FINAL
ENVIRONMENTAL IMPACT STATEMENT
FOR THE
STRATEGIC TARGET SYSTEM

Volume I

Final
**ENVIRONMENTAL IMPACT STATEMENT
FOR THE
STRATEGIC TARGET SYSTEM**
Volume I
Responses to Comments and Changes to Draft EIS

Figure 2-4. Strategic Target System launch vehicle comparison.

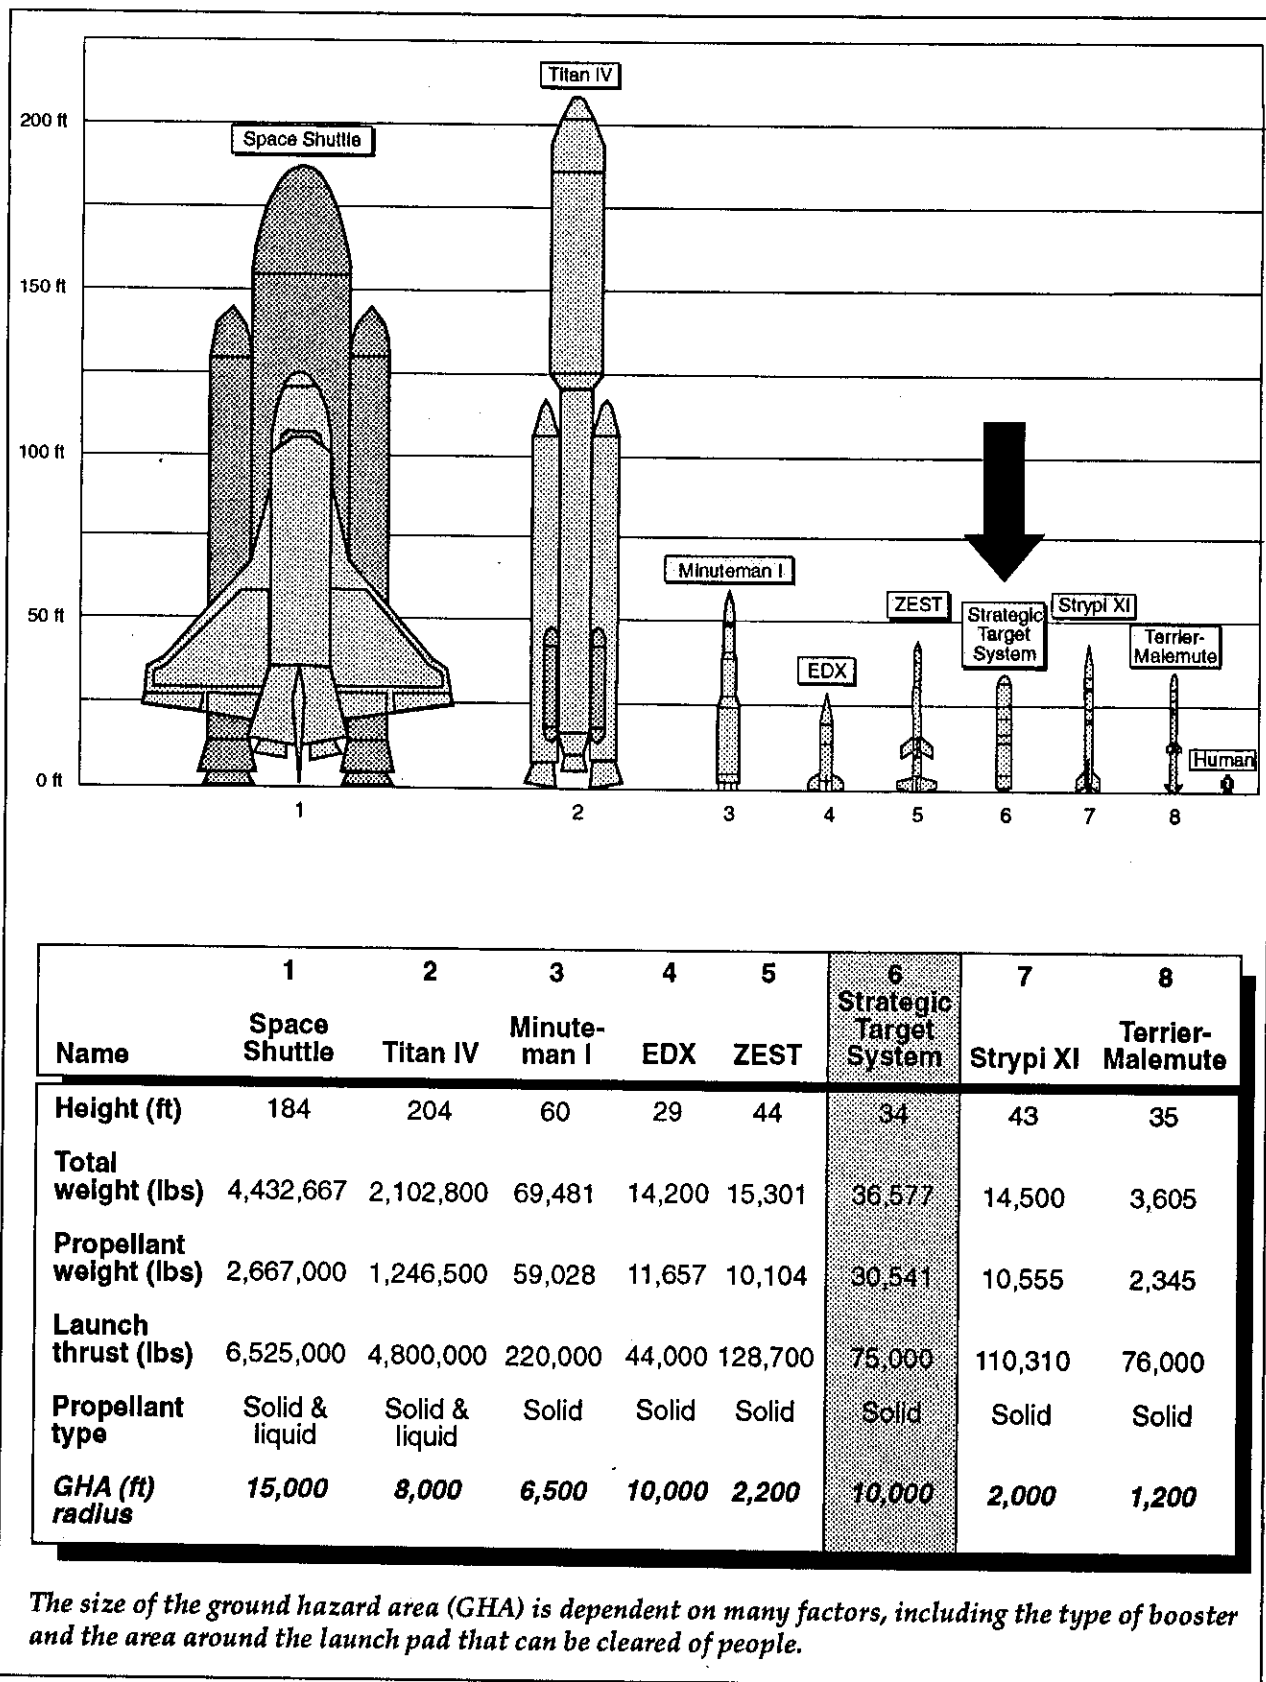
Response to comment OR138-3: See Chapter 2, Additions and Revisions to the Draft EIS, where Figure 2-4 has been revised to show the ground hazard areas for each of the other rockets.

Response to comment WR231-6: Figure 2-4 of the Draft EIS has been revised to reflect ground hazard areas for the comparison rockets.

Page 2-5, Figure 2-4: Figure has been revised as shown on page 2-2.

Response to comment WR33-2: Figure 2-4 of the Draft EIS has been modified. The age of the boosters used in the sounding rocket launches is less than five years. The age of the Aries boosters used in the EDX program is between 20 to 30 years.

Figure 2-13. Strategic Target System ground hazard area.

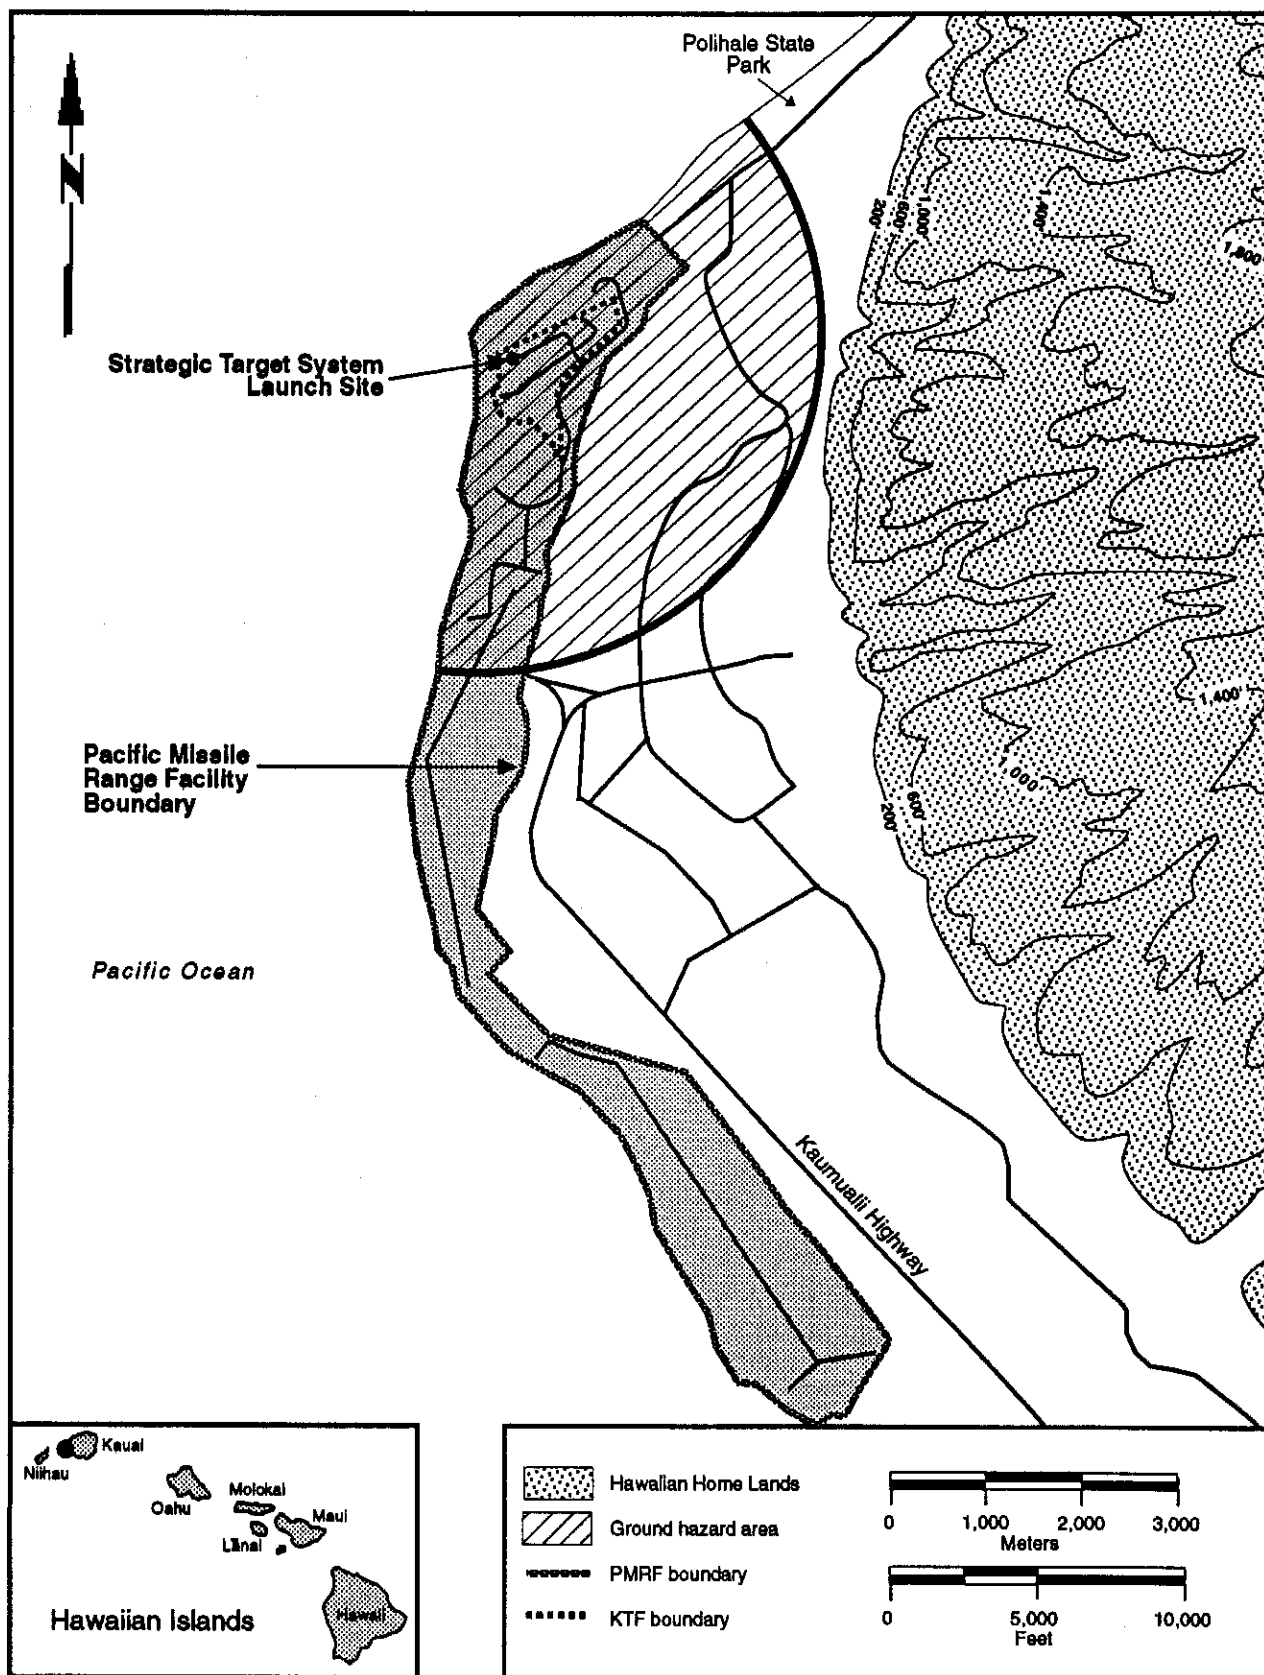
Response to comment WR67-1: As shown on page 2-23, Figure 2-13 of the Draft EIS, the Strategic Target System activities, including the ground hazard area do not affect lands designated as Hawaiian Home Lands. See also response to comment OR7-1.

Page 2-23, Figure 2-13: Figure has been revised as shown on page 2-4.

Figure 4-1A. Pacific Missile Range Facility recreational areas.

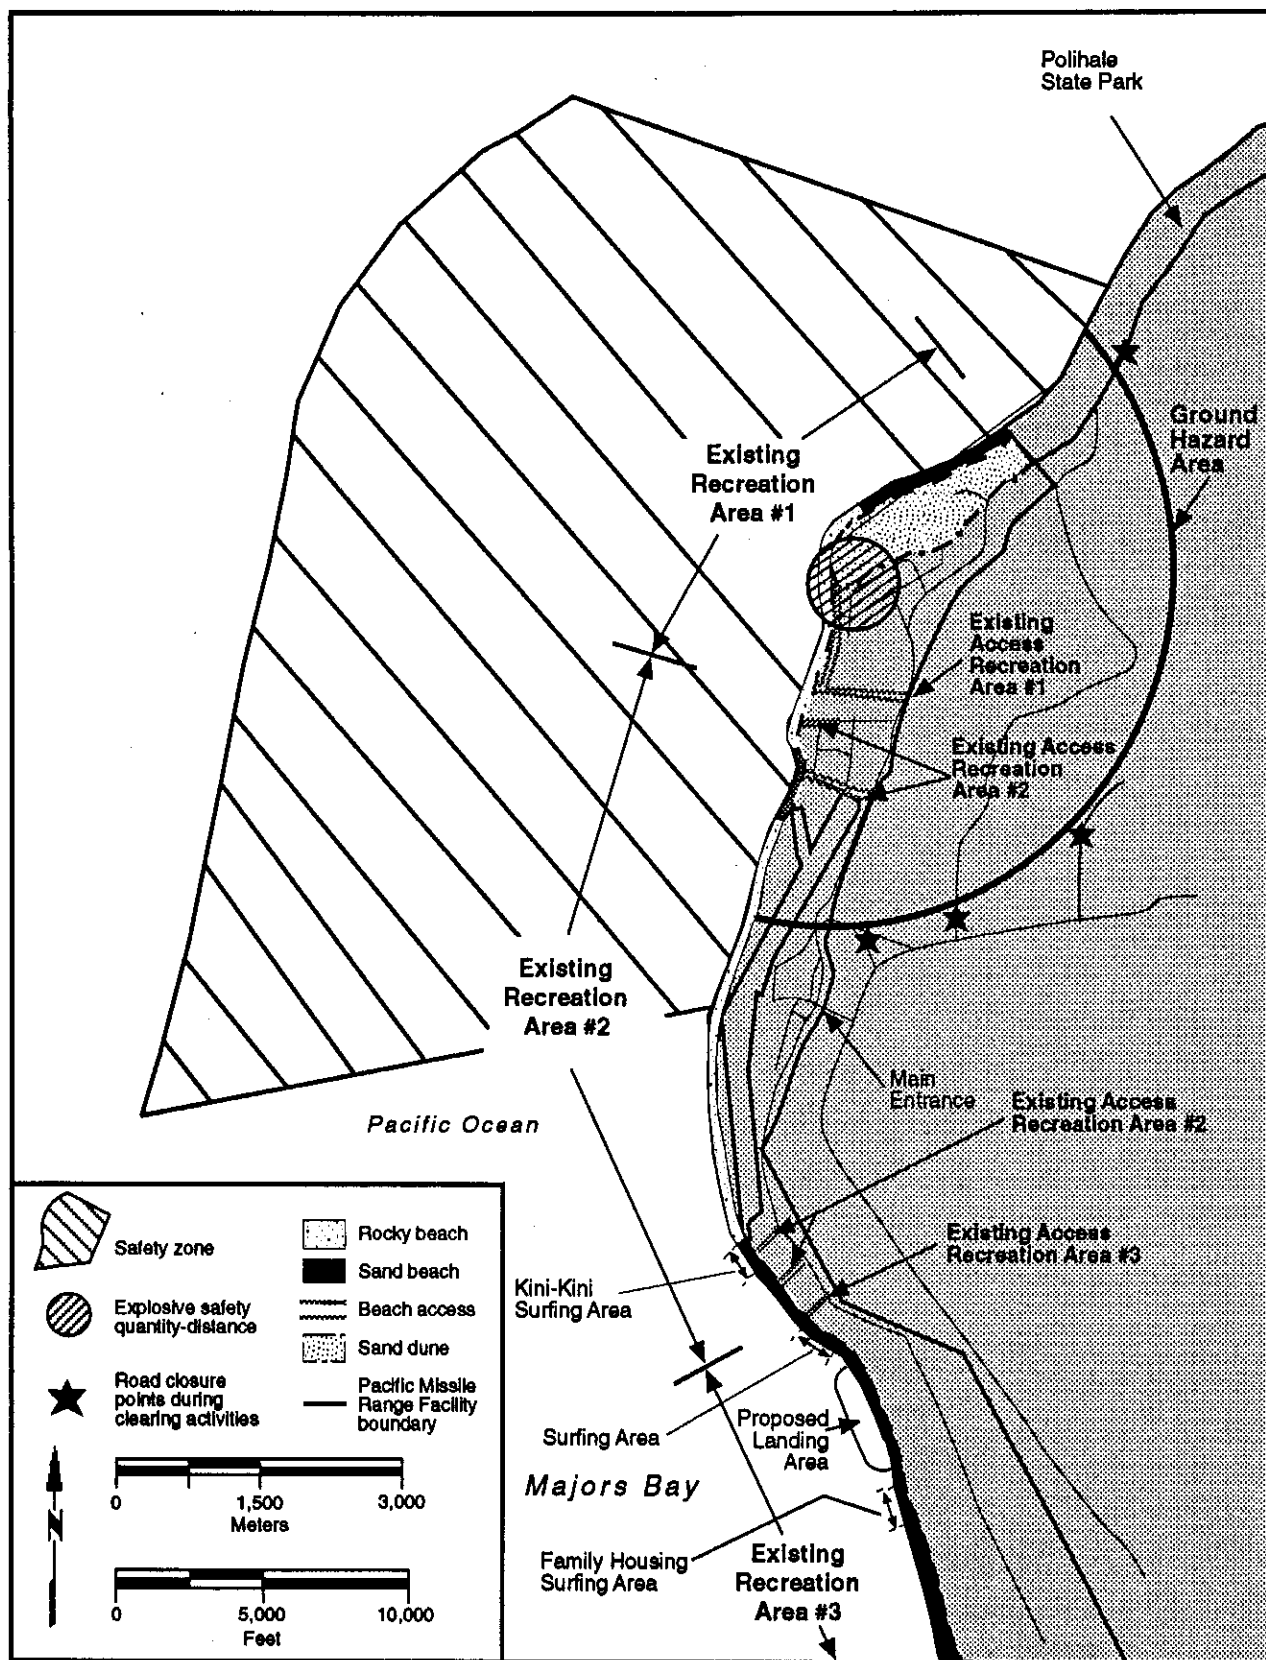
Response to comment OR1-6: The portion of the coastline affected by the closure (explosive safety quantity-distance) imposed when the vehicle is on the launch pad is a small portion of Recreation Area #1 (see Draft EIS, Figures 3-9 and 4-1) on PMRF. While, on the whole, the beaches on PMRF are popular portions of the coastline, the small (~ 0.5 mile) stretch of beach affected by the 56-day-per-year closure has a history of more limited use. During a recent 3-year period, 11% of the people who signed in at the gate to use the beaches at PMRF said their destination was Recreation Area #1. Of these, 43% said they were going there to fish.

A figure has been added to clarify the exact portion of Recreation Area #1 that would be closed for 56 days a year and its relationship to other beach areas of PMRF. This figure can be found in Chapter 2 of this volume.
